**Addendum #4**

PROJECT #: ET-0073-B01
Paul Robeson Community Theme School for the Arts
Addition and Renovations
New Brunswick Public Schools

DESCRIPTION: Addendum #4

C-01

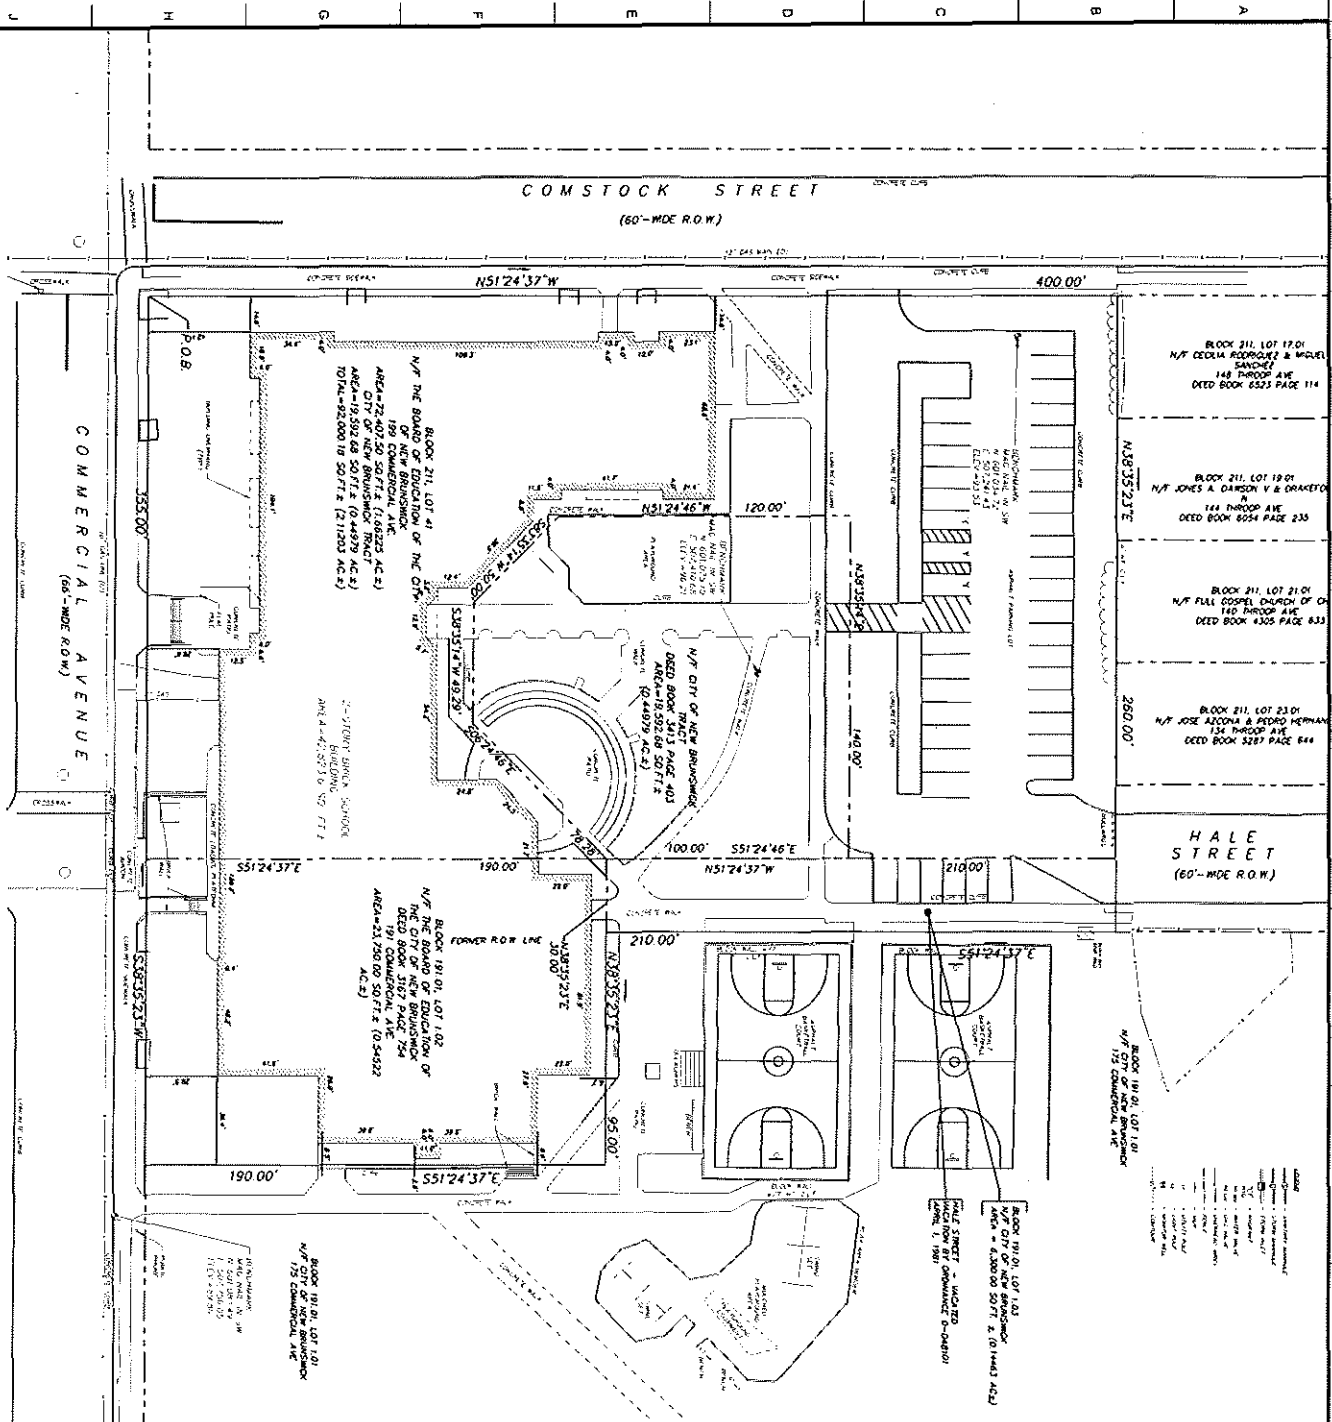
1. **REPLACE:** Drawing C-01 Boundary Survey, dated April 20, 2015, with Revised Drawing C-01 Boundary Survey, dated June 17, 2015, issued herewith as Attachment 4.1. All other plans, sections and elevations are modified accordingly by implication.
